ADDENDUM NO. 1

RE: HIGH SCHOOL #13

Howard County Public School System

Bid Number: 016.20.B4

dwg
 ADD_1_S1

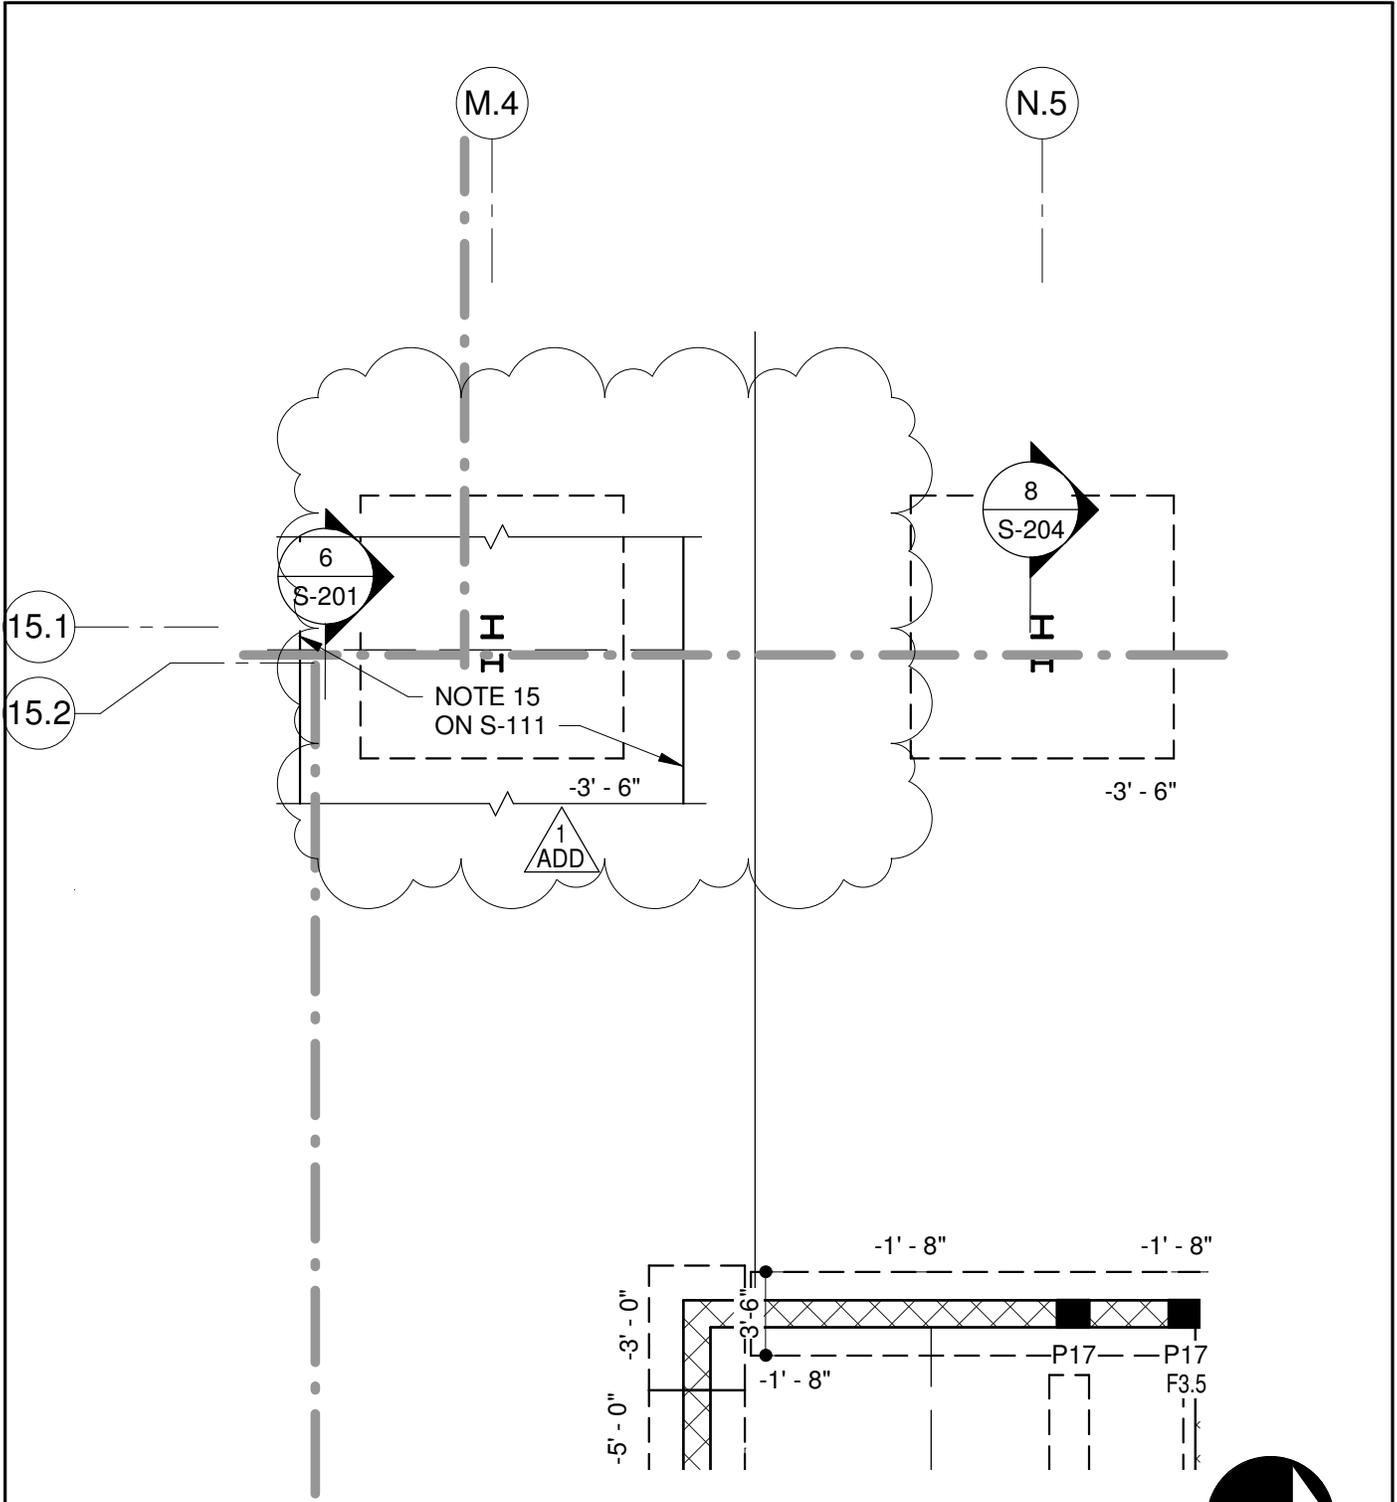
- ADD** Slab control joint to plan, section cut 6/S-201 and corridor terrazzo depression "NOTE 15 ON S-111" near column S-14.9 and M.4-15.1 as shown on attached part plan ADD_I_S1 and ADD_I_S2.

<p>HIGH SCHOOL #13 JESSUP, MARYLAND HOWARD COUNTY PUBLIC SCHOOL SYSTEM</p>	 <small>Structural Engineers Parking Consultants © Copyright Morabito Consultants, Inc.</small>	<p>date Checker</p> <hr/> <p>dwg ADD_1_S3</p>
---	---	---

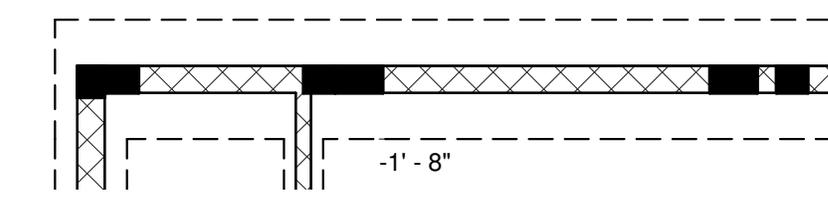
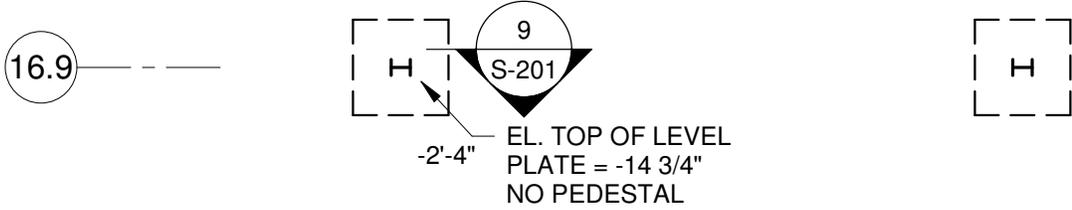
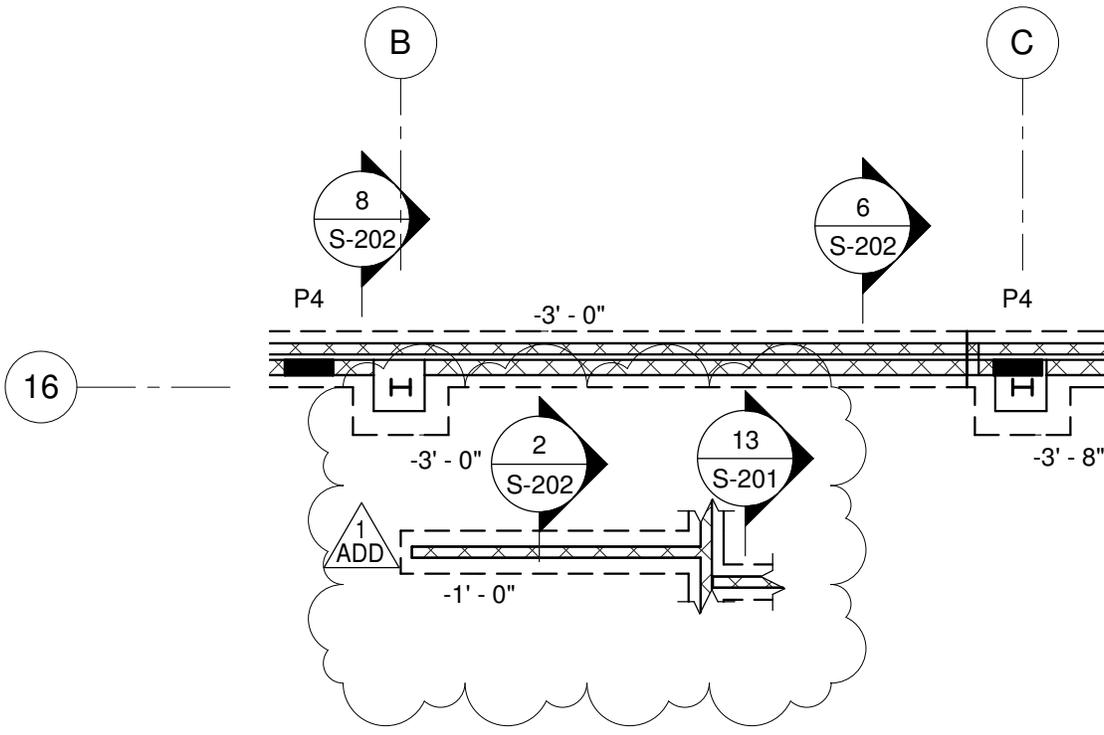
- ADD** Add slab control joint to plan, section cut 6/S-201 and corridor terrazzo depression "NOTE 15 ON S-111" near column G-15.1 as shown on attached part plan ADD_I_S3.
- ADD** Add foundation for cantilevered wall and section cut 2/S-202 east of column B-16 as shown on attached part plan ADD_I_S4.

<p>HIGH SCHOOL #13 JESSUP, MARYLAND HOWARD COUNTY PUBLIC SCHOOL SYSTEM</p>	<p>morabito consultants</p> <p>Structural Engineers Parking Consultants © Copyright Morabito Consultants, Inc.</p>	<p>date 21 JAN 20</p> <p>dwg ADD_1_S5</p>
---	--	---

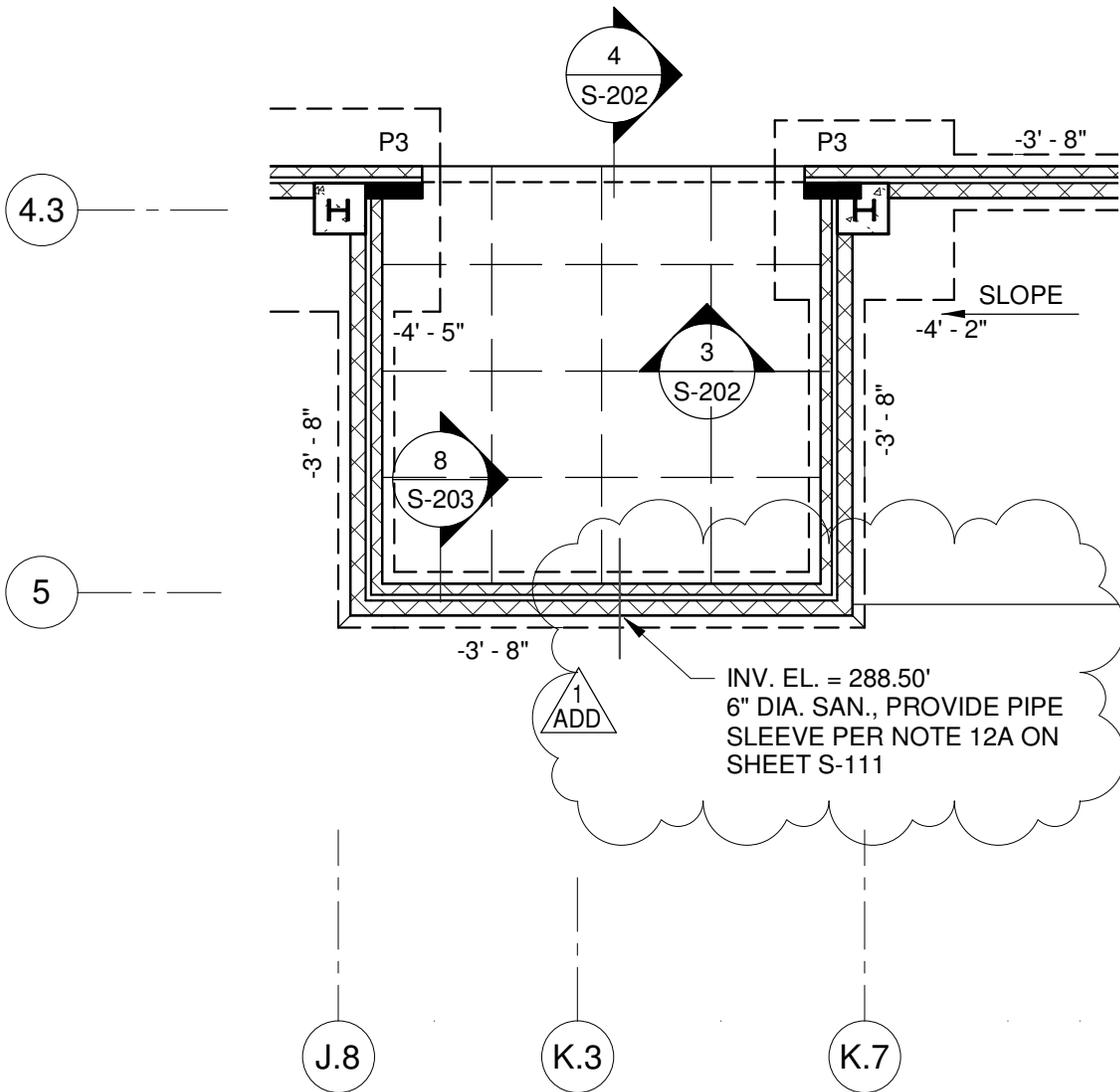
- ADD** Add roof top unit DSS 200 lbs, to plan just north of W14x22 beam on column line Q as shown on attached part plan ADD_I_S5.

dwg
ADD_1_S6

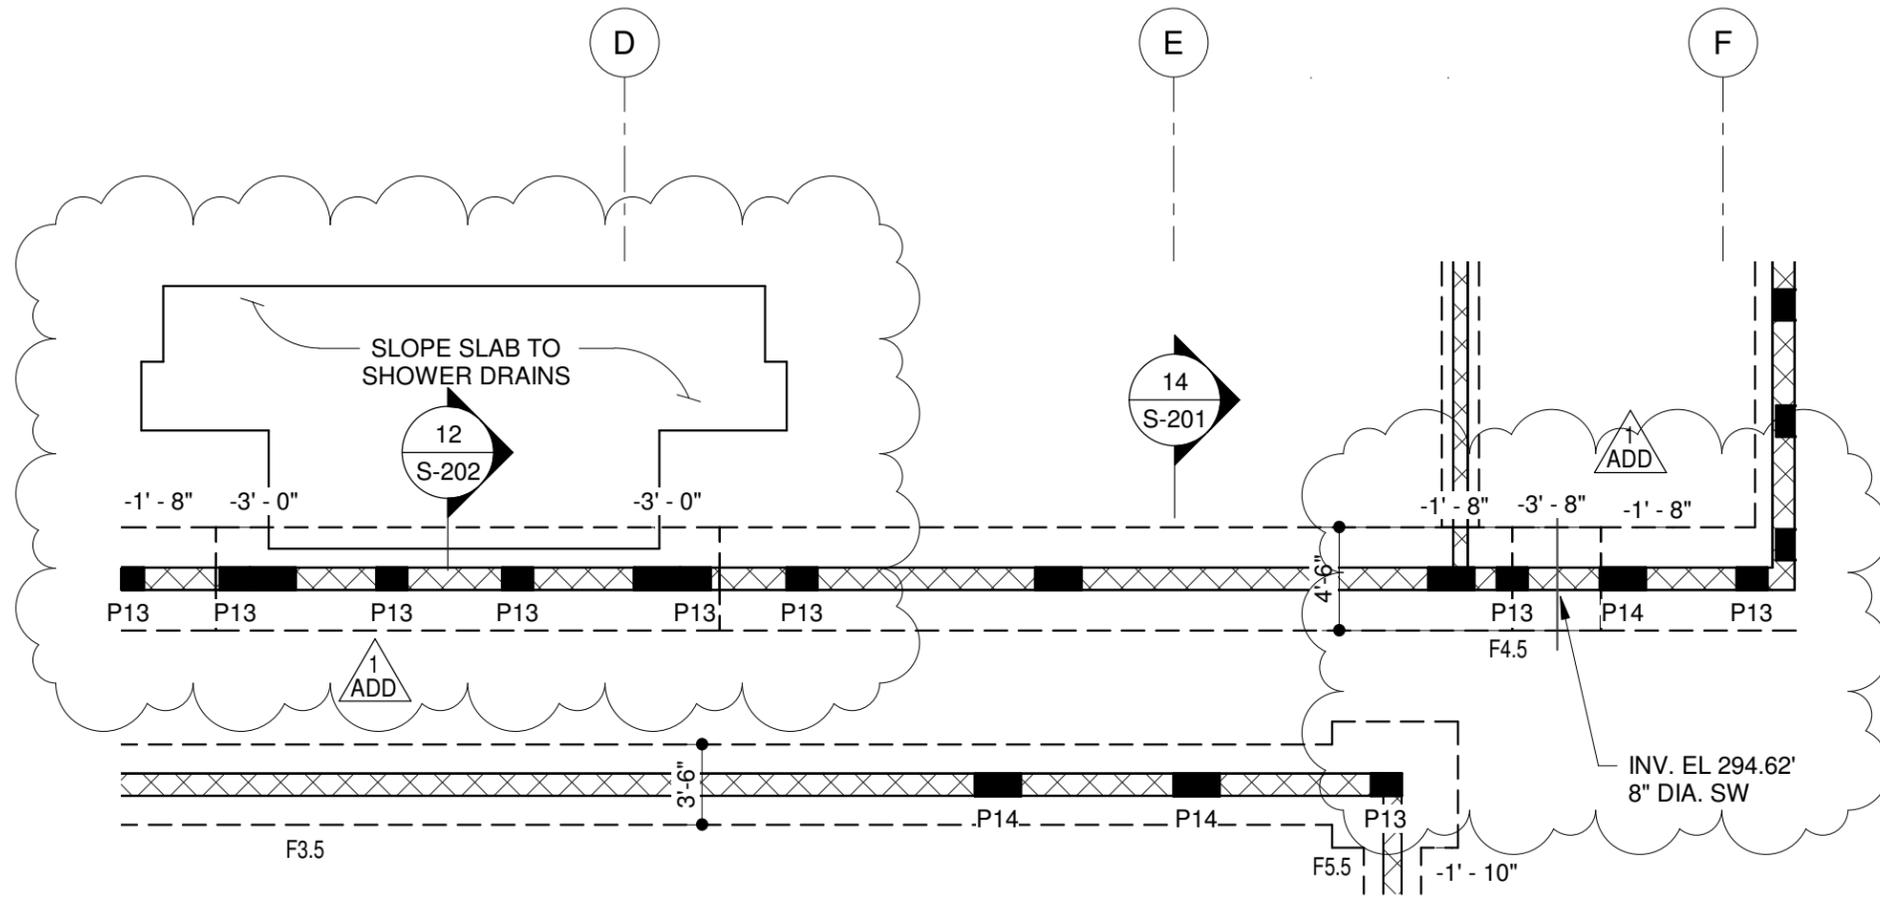
- REVISE** Invert elevation note near intersection of column line K.3-5 to read as follows:
 From: "INV. EL. = 285.00' 6" DIA. SAN"
 To: "INV. EL. = 288.50' 6" DIA. SAN.X PROVIDE PIPE SLEEVE PER NOTE 12A ON SHEET S-111" as shown on attached part plan ADD_I_S6.

dwg
ADD_1_S7

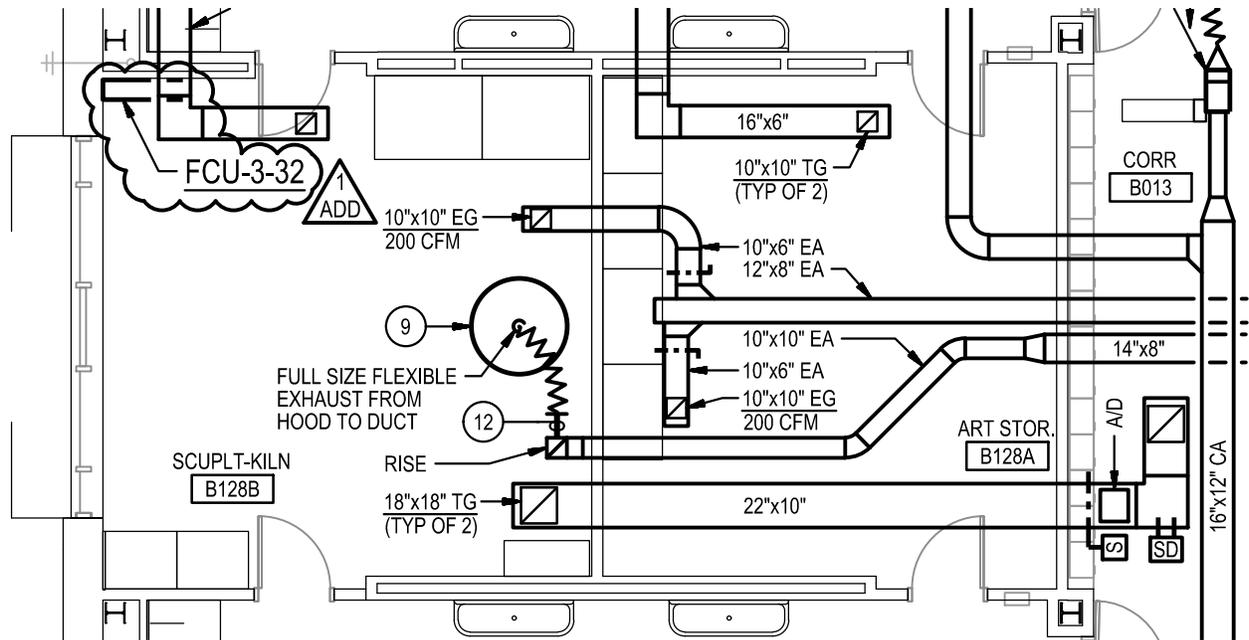
- REVISE** Footing elevations at shower drains and under slab pipe as shown on attached part plan ADD_I_S7.

dwg
 ADD_1_M1

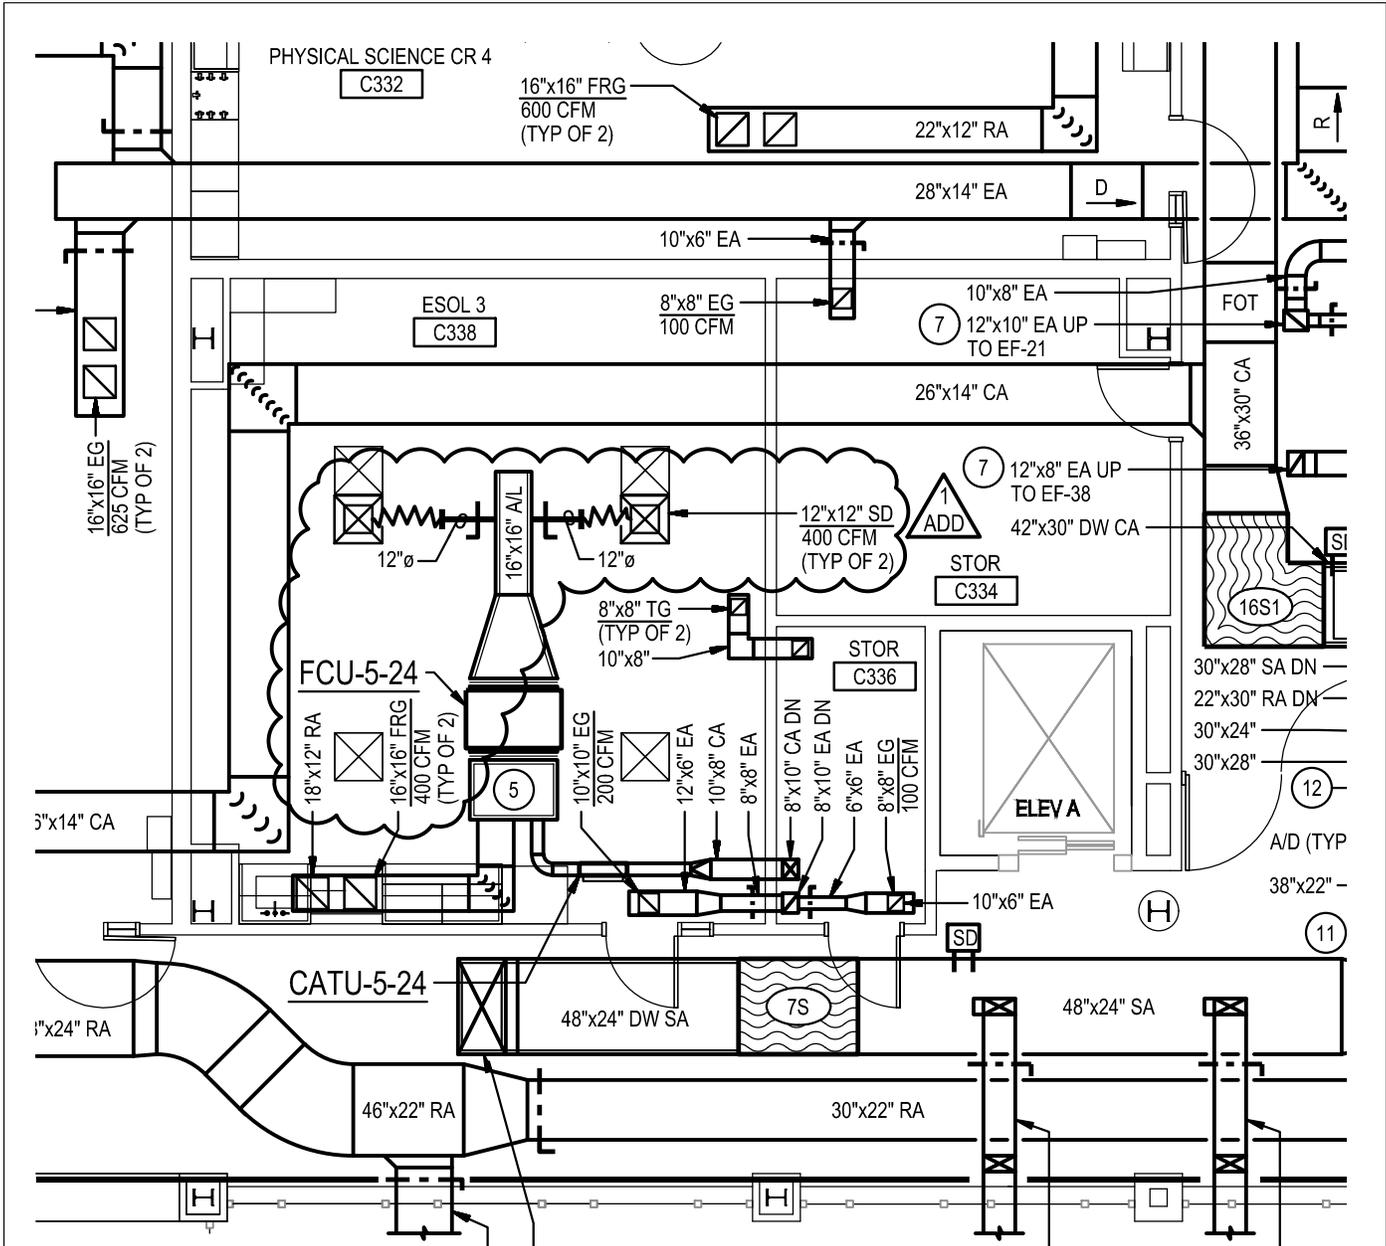
- DELETE** Cabinet unit heater CUH-1-8 from Sculpt-Kiln per sketch ADD_I_M1.
- ADD** Fan coil unit FCU-3-32 to Sculpt-Kiln per sketch ADD_I_M1.

dwg
ADD_1_M2

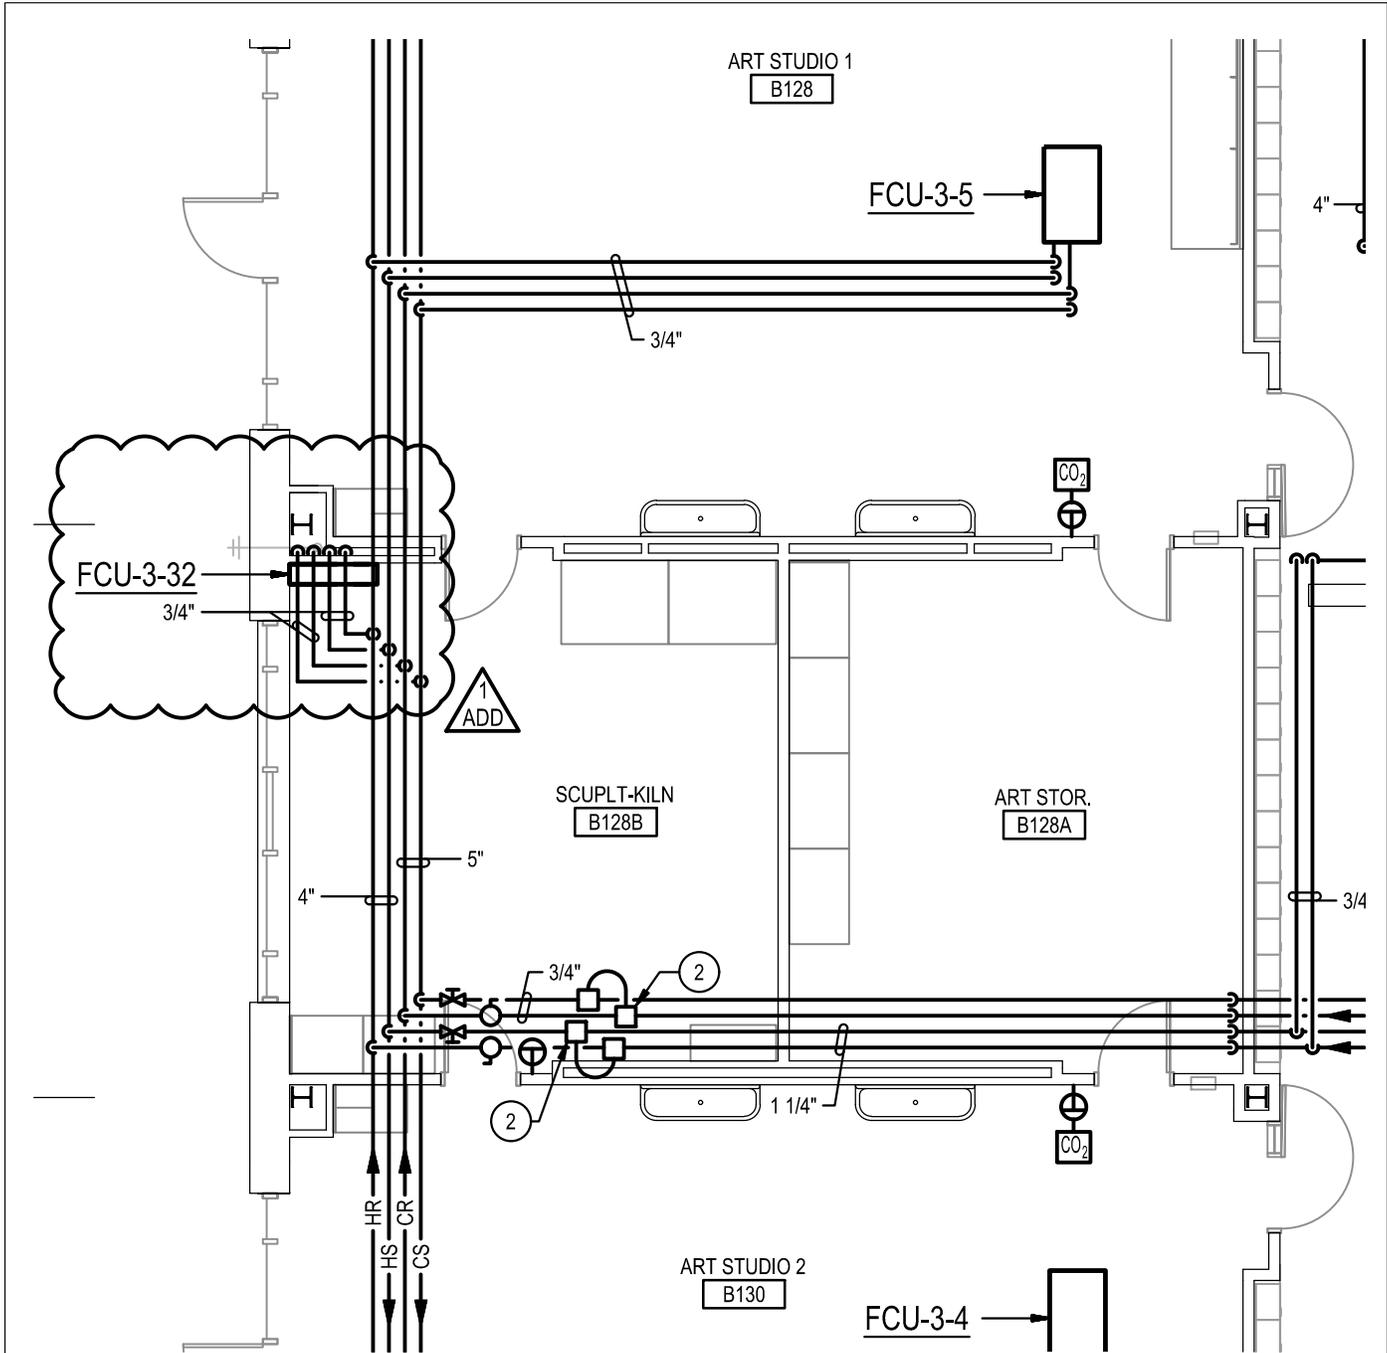
REVISE Ductwork and air devices serving fan coil unit FCU-5-24 per sketch ADD_I_M2.
